Insulet Corporation

RE: FCC Permissive II Change Request
Applicant: Insulet Corporation
FCC ID: RBV-SAW

OmniPod DASH (FCC: RBV-SAW, Original Grant Date: 16-April-2020).

Objective of Change: The SAW Dash Pod (MyBlue DASH Generation 2) is a program that introduces a lower cost / reduced complexity version of MyBlue (DASH) Pod to the market. The objective of this change is to optimize the antenna impedance matching network to improve communications reliability.

Figure 3 – PCB Assembly

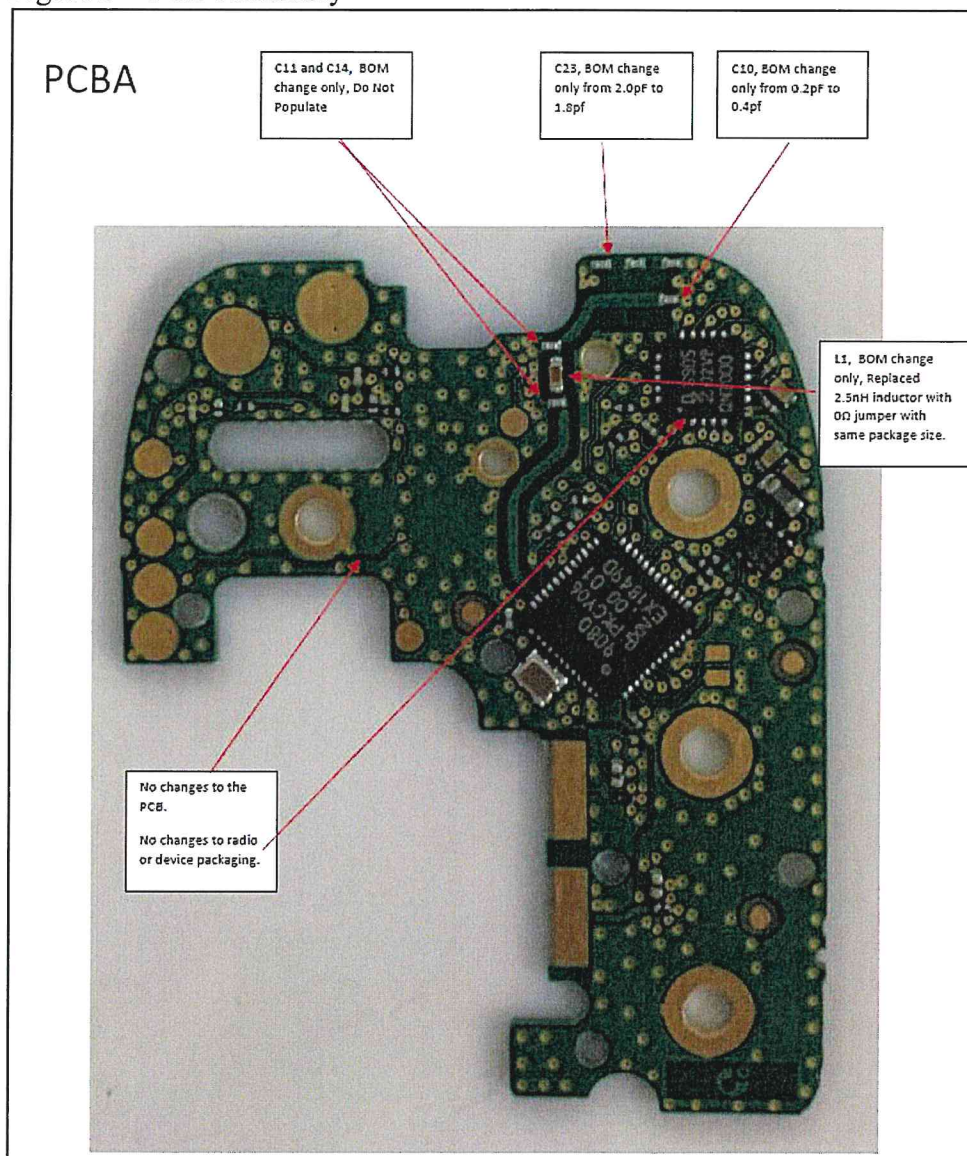
Key changes to the antenna impedance matching network are described below. See images/illustration below.

Figure 3 reflects the resulting schematic changes from Figure 2 above. The Printed Circuit Board (PCB) has not changed and it is the same as was submitted during the original FCC grant dated 16-April-20. In addition, it is pointed out that device packaging has not changed.
